Distr.: General 8 September 2021

World Forum for Harmonization of Vehicle Regulations

> Proposal for Supplement 7 to the 06 series of amendments to UN Regulation No. 49 (Emissions of compression ignition and positive ignition (LPG and CNG) engines)

Submitted by the Working Party on Pollution and Energy*

Figure 12 Scheme of partial flow dilution system (total sampling type)

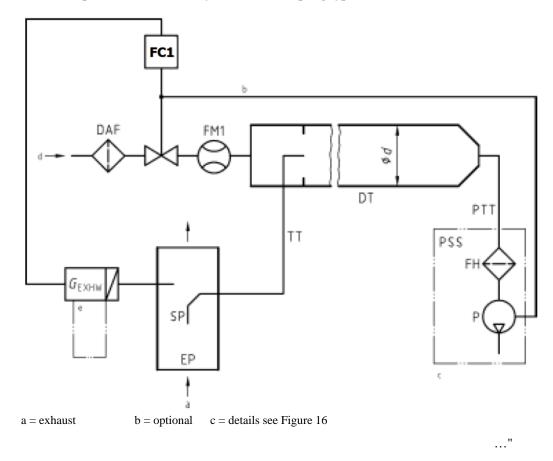
Paragraph A.2.2.1., amend to read:
